South Texas Project Electric Generating Station P.O. Box 289 Wadsworth, Texas 77483

South Texas Project
Units 1 and 2
Docket Nos. STN 50-498, STN 50-499
Response to Requests for Additional Information for the
Review of the South Texas Project, Units 1 and 2,
License Renewal Application – Set 26 (TAC Nos. ME4936 and ME4937)

STP Response to Requests for Additional Information

The staff has completed its evaluation of the response to request for additional information (RAI) B2.1.37-4 related to the Selective Leaching of Aluminum Bronze plant-specific aging management program (AMP). As a result of this review, there are several open questions.

Ultimate Tensile Strength Data for Al-Brz Castings at Room Temperature

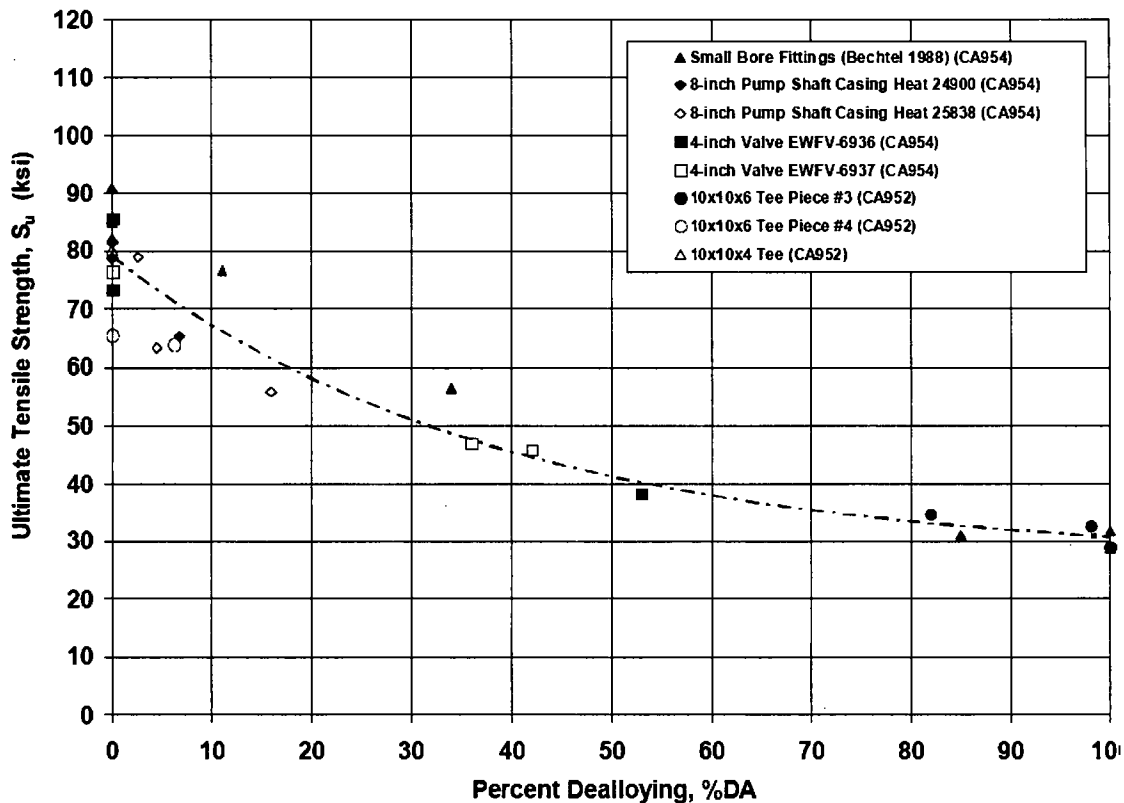
STP Observation:

The reduction in material strength is consistent with the earlier work and shows an asymptotic limit of 30 ksi, based on the regression analysis of the test data. This is the same limit value assumed in the 1994 integrity assessment for the fully-dealloyed condition.

0.2% Offset Yield Strength Data for Al-Brz at Room Temperature

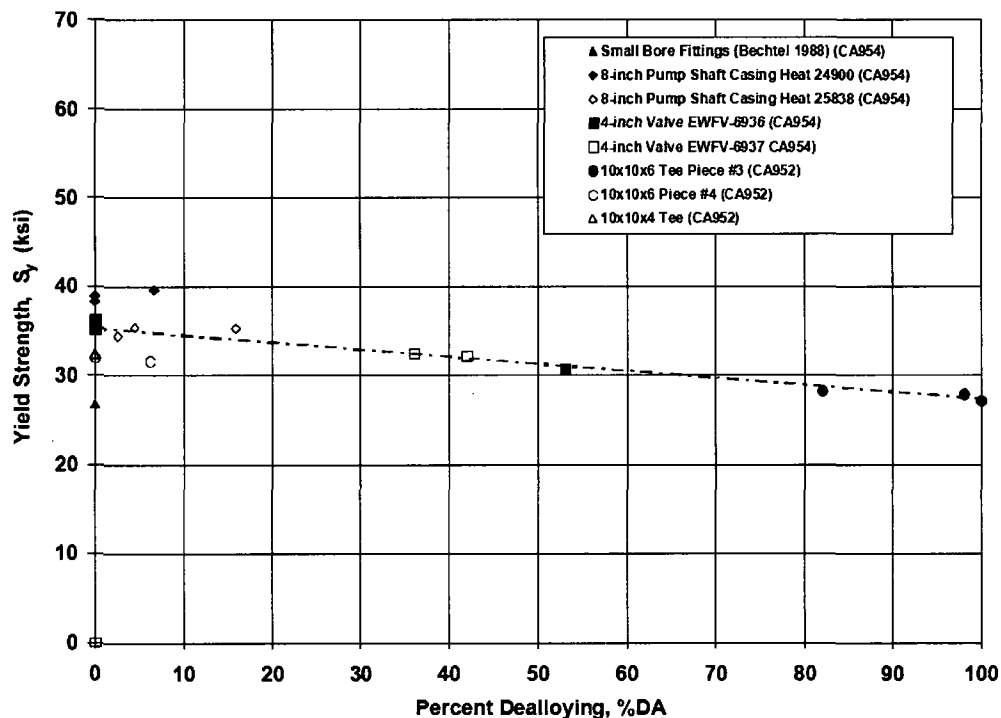
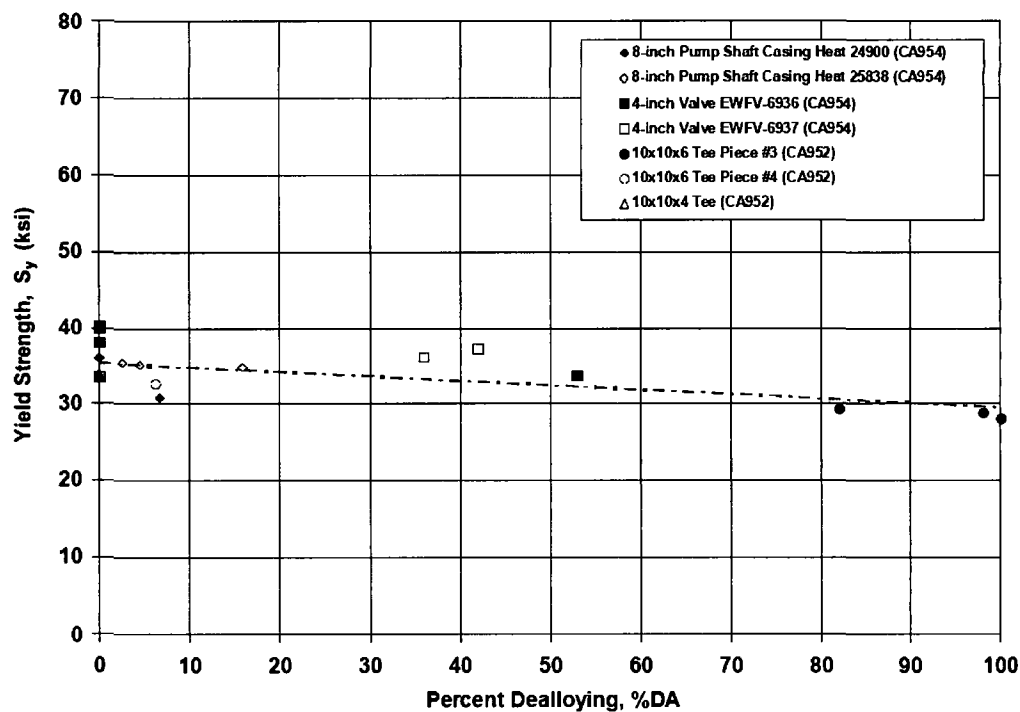
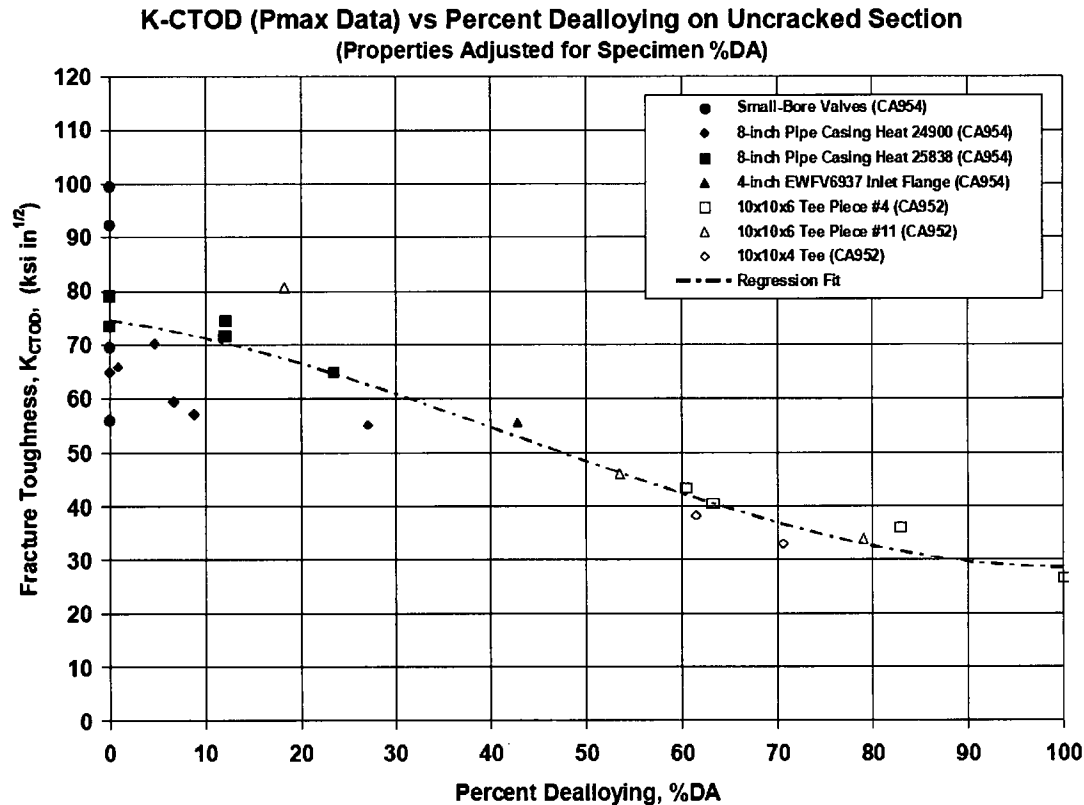
The trend in yield strength (approximately 28 Ksi) has been established, and has been determined to be consistent with that of the ultimate strength.

Chemical Testing

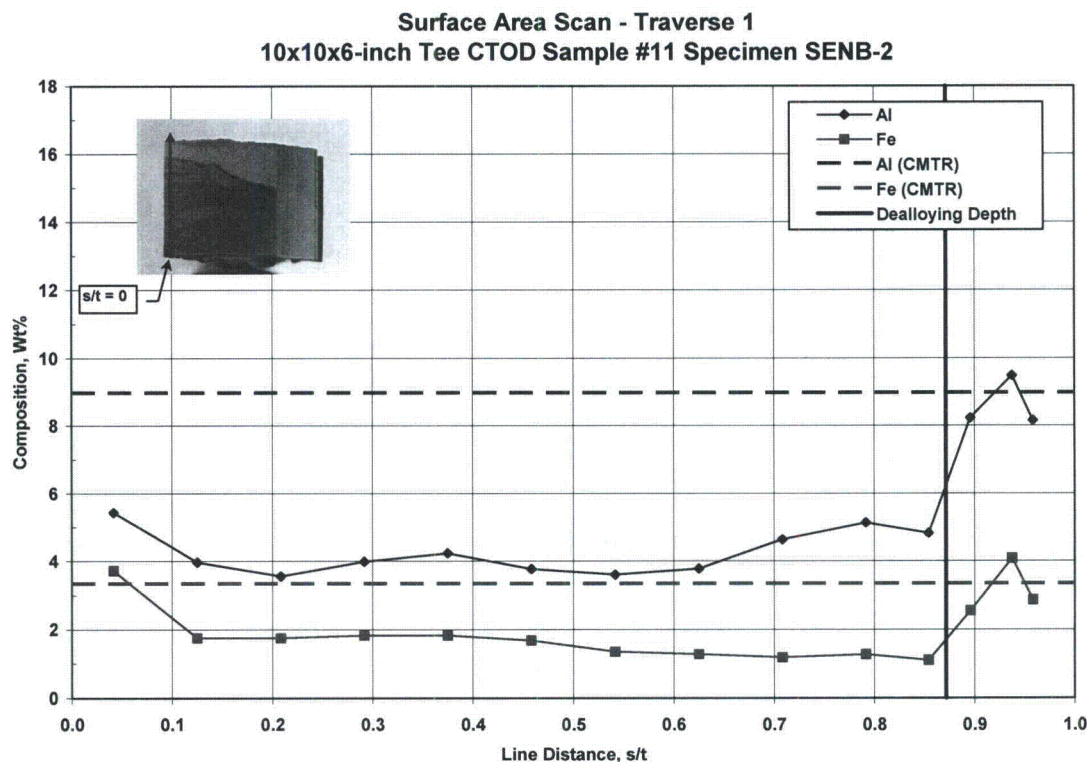
STP has tested some selected samples of fractured surfaces for aluminum content by percent (%) weight. These measurements are obtained by taking detailed surface area scans of 1 mm² in size along the linear traverses across the fracture surfaces using the Scanning Electron Microscope (SEM) and EDS. These scans included both dealloyed and undealloyed regions to obtain the distribution of Al, Fe, and Cu content within these regions.

STP observed that the transition from dealloyed to undealloyed Al-Brz is sharp and distinct, and visible to the eye. It is evident from the figure below that the Al and Fe compositions along the fracture surface (Traverse 1) indicate a relatively uniform but reduced amount of both Al and Fe within the dealloyed region from the ID surface to the maximum depth of dealloying. Beyond that point, the compositions of Al and Fe exhibit a step increase in magnitude within the undealloyed Al-Brz material.

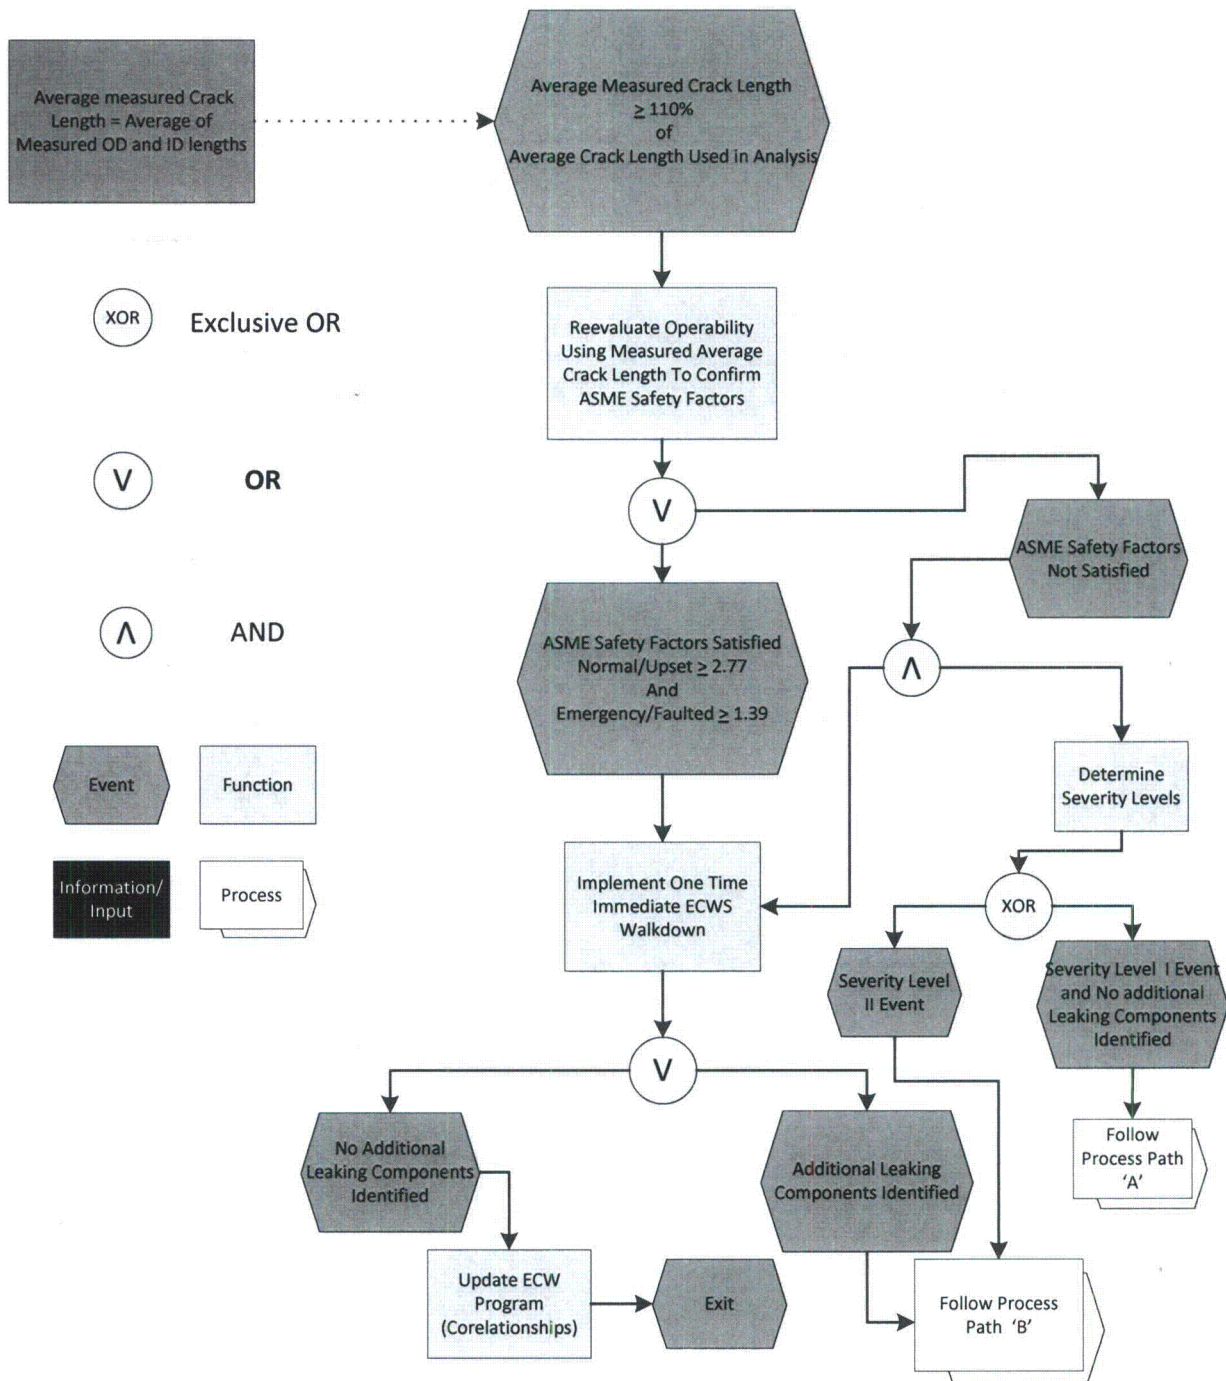
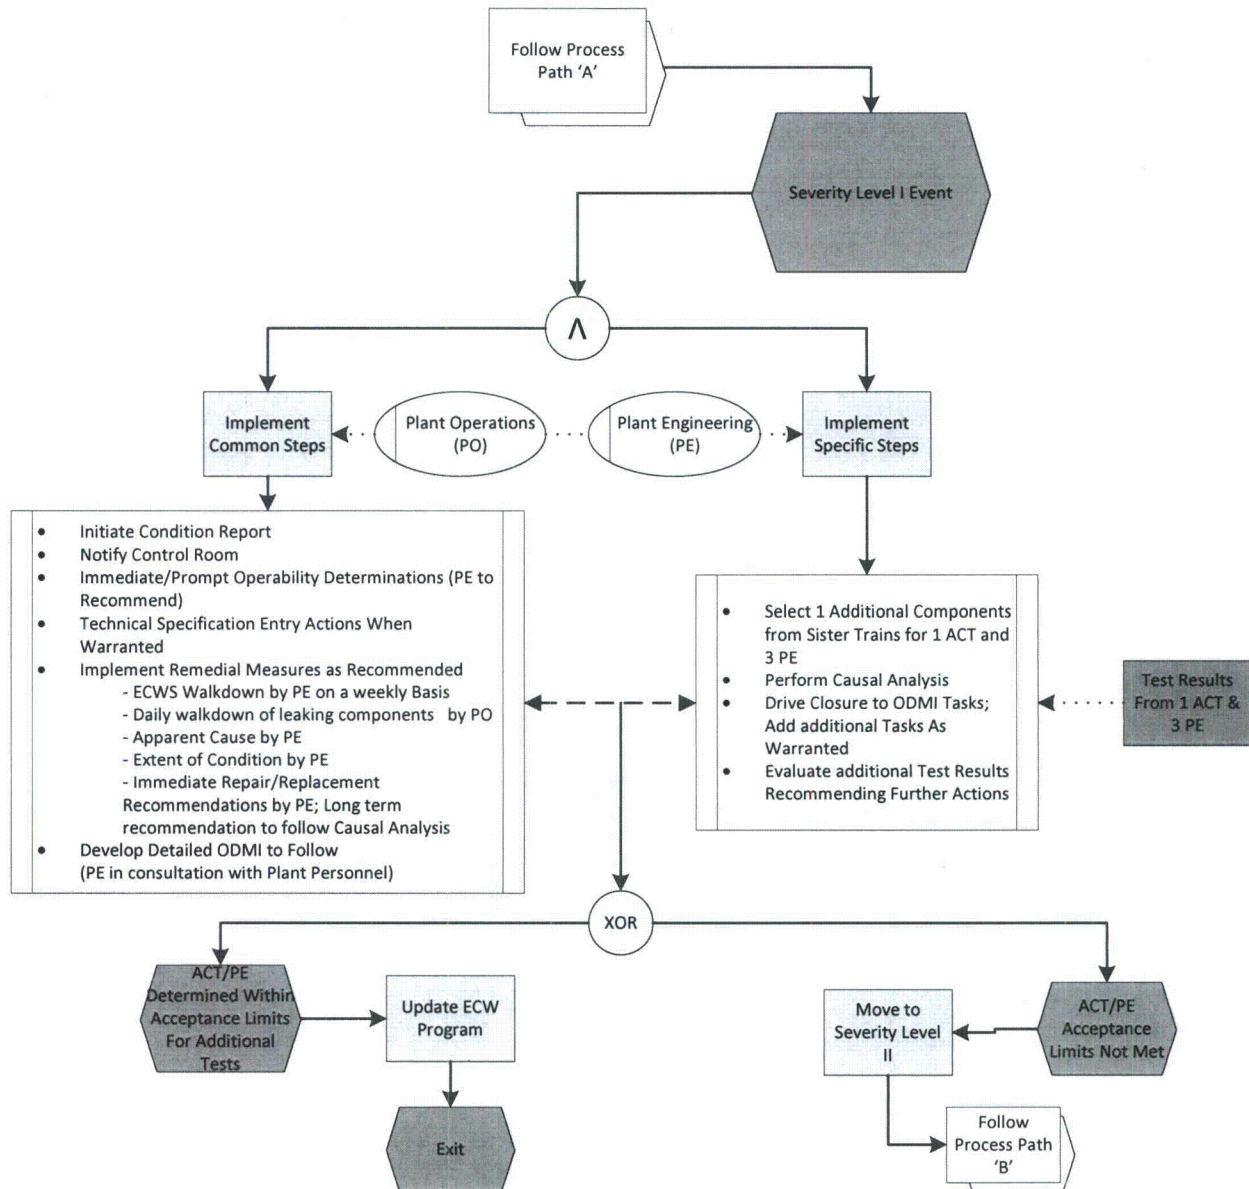
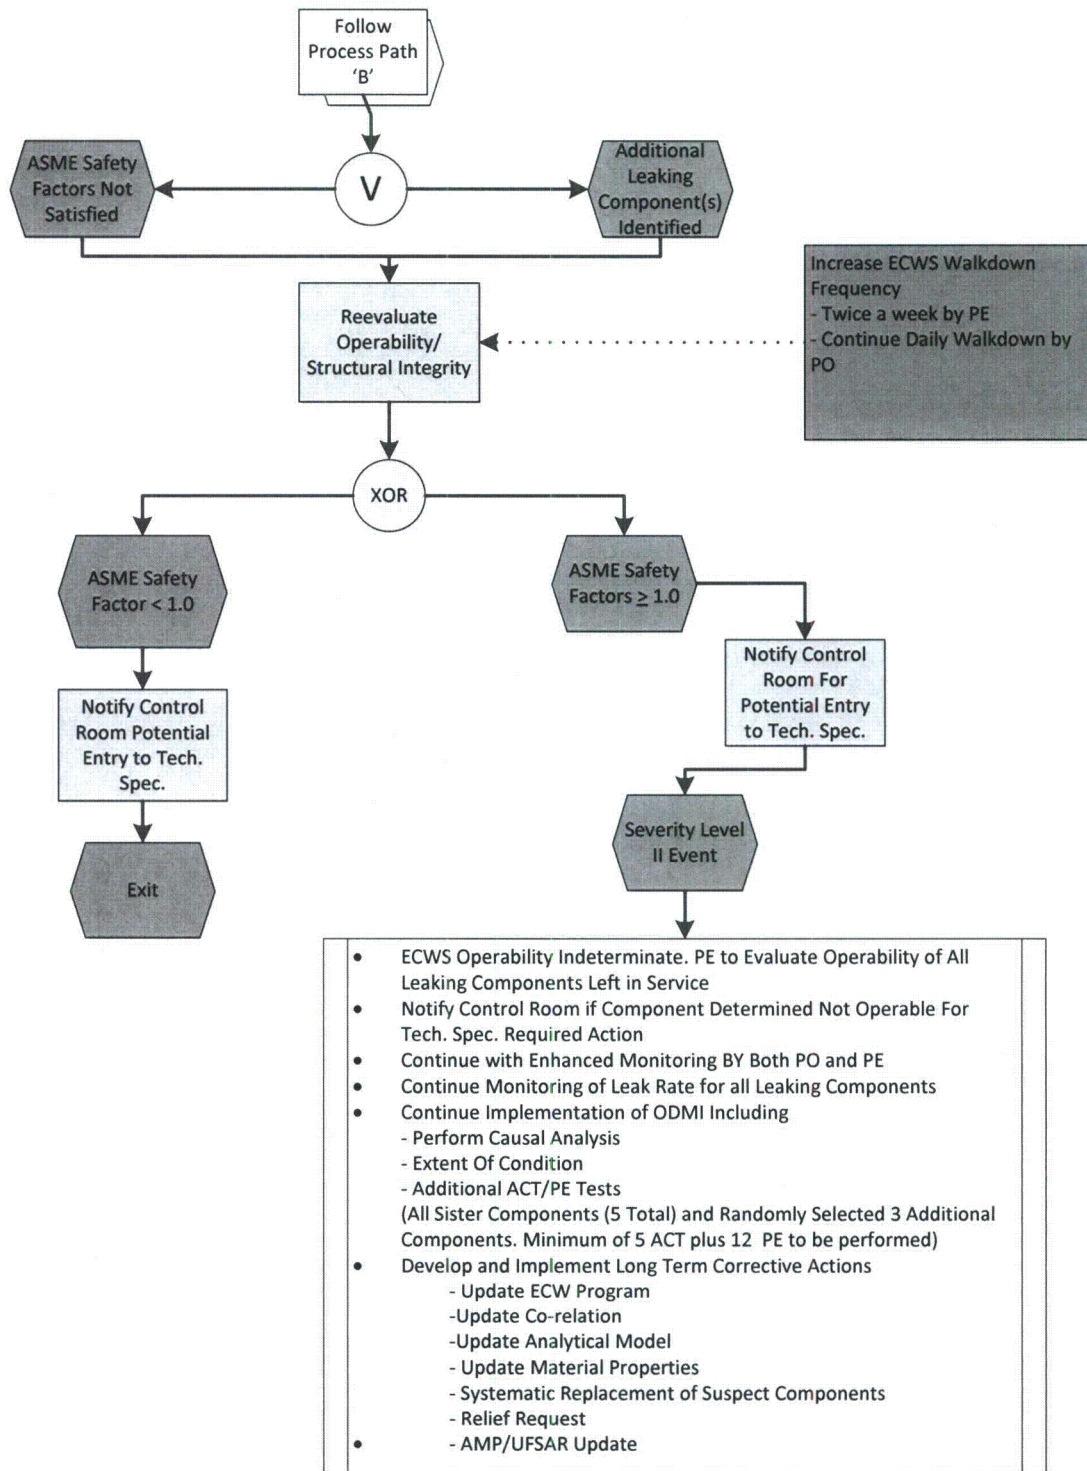
- An ACT test result yields a data point below the size-appropriate acceptance curve (e.g., Figure 4-2, "Evaluation of Flange Bend Test Results," in AES-C-1964-5)

The following ASME Section XI Appendix H or C safety factors determine severity levels. The safety factors are recalculated using the average crack length to determine severity.

Severity Level	Normal/Upset Condition	Emergency /Faulted Condition	Number of Additional Tests
II	$SF \leq 1.5$	$SF \leq 1.2$	2 ACTs on sister component from remaining trains 5 PEs
I	$SF > 1.5$ and $SF < 2.77$	$SF > 1.2$ and $SF < 1.39$	1 ACTs 3 PEs

If the recalculated safety factors are within the ASME Code allowed limits, no additional actions are required other than precautionary actions intended to address the extent of condition as shown in the following Decision Flowcharts.
